From: Jeremy Sergeant
Sent: 08 April 2014 09:49
To: Matthew Porter
Subject: AWDM/0309/14

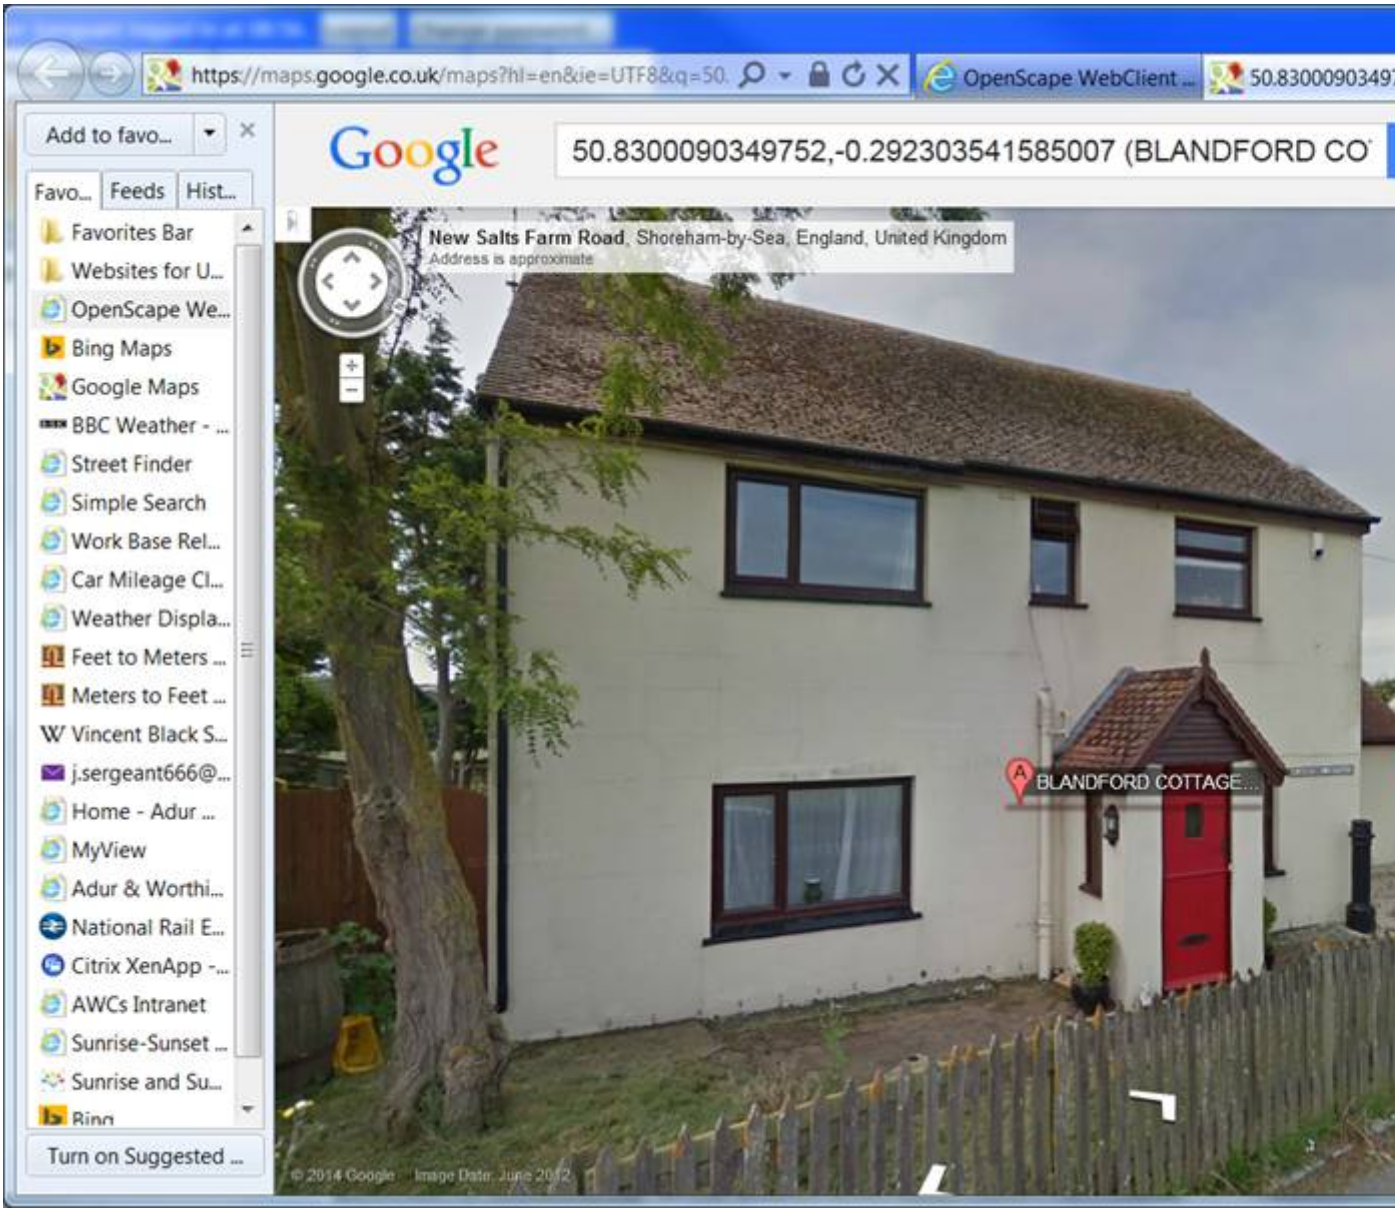
Thank you for your e-mail I have taken a look at the plans and street view of this application and I am not sure that the existing trees are shown on the plan as close as they really are/ will be.

If, what appears to be an Ash tree is to be retained it will be very close and directly in front of the proposed extension. Although this maybe possible as there is existing hard standing and new foundations can be designed to take into account the close proximity of the tree, I feel that future pressure will affect the trees retention. Particularly as it appears to have a low wide crown, leaving few options when considering light and overhang.
